Access Compliance Report Public Rights-of-Way (Curb Ramps)

Main Street: **BRENAN_WAY** Cross Street: **AUBURN_AVE** Location: **NE**

ADA ID: **RPAT211006135857** Ramp Type: **Type 4 - Parallel** Initial Pass/Fail: **Pass** Overall Compliance: **No** Severity Score: **2**

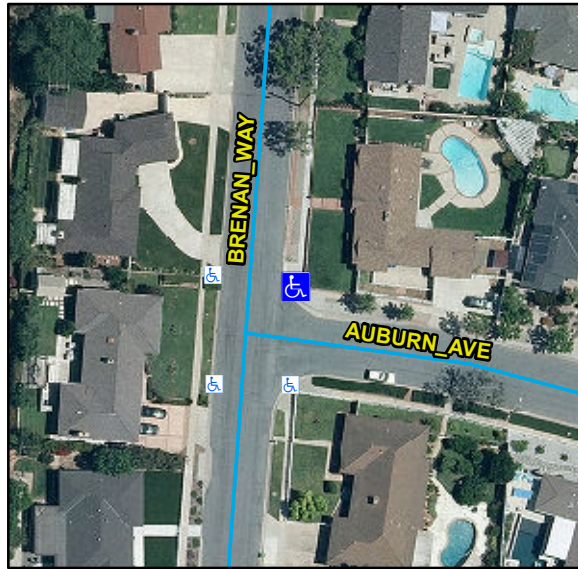
Remove & Replace Curb Ramp With Two New Directional Ramps or Equivalent. Gutter Ponding Observed.

Compliance	Description	Data	Compliance	Description	Data
N/A	Ramp Length LT (in)	62	N/A	Ramp Length RT (in)	96
Yes	Ramp Width LT (in)	84	Yes	Ramp Width RT (in)	102
Yes	Ramp Run Slope LT (%)	5.7	Yes	Ramp Run Slope RT (%)	5.8
Yes	Ramp Cross Slope LT (%)	2	No	Ramp Cross Slope RT (%)	2.9
N/A	Landing Present	Yes	Yes	DWS Provided	Yes
N/A	Landing Length (in)	60	Yes	DWS Contrast	Yes
Yes	Landing Width (in)	48	Yes	DWS Length (in)	36
No	Landing Run Slope (%)	2.7	Yes	DWS Full Width	Yes
Yes	Landing Cross Slope (%)	1.3		DWS Offset Type	Single
N/A	Landing Movement Obstructed?	No	Yes	DWS Offset Left (in)	0
	Landing Movement Type	Curb	Yes	DWS Offset Right (in)	N/A
N/A	Landing Shared	No			
N/A	Clear Space	Yes			
N/A	Clear Space To Crosswalk (in)	48			
N/A	Marked Crosswalk 1	No	N/A	Marked Crosswalk 2	No
	Crossing 1 Direction	W		Crossing 2 Direction	S
	Marked Crosswalk 1 Width (in)	N/A		Marked Crosswalk 2 Width (in)	N/A
N/A	Ramp Inside Crosswalk 1	N/A	N/A	Ramp Inside Crosswalk 2	N/A

Crossing 1 Slope (%)	4.8		Crossing 2 Slope (%)	1.6
	Crossing 1 Cross Slope (%)	0.7		Crossing 2 Cross Slope (%)	3.5
No	Gutter Ponding	Yes	N/A	Curb Slope	7.6
Yes	Gutter Lip Height (in)	0		Road Run Slope (%)	1.2
Yes	Gutter Run Slope (%)	2.4		Road Cross Slope (%)	3.8
Yes	Gutter Cross Slope (%)	0.4	Yes	Perpendicular Joint Present	Yes
Yes	Overall Surface Condition	Acceptable			
	Cross Gutter Present?	No		Spandrel Present?	No
	Replace Cross Gutter?	N/A		Replace Spandrel?	N/A
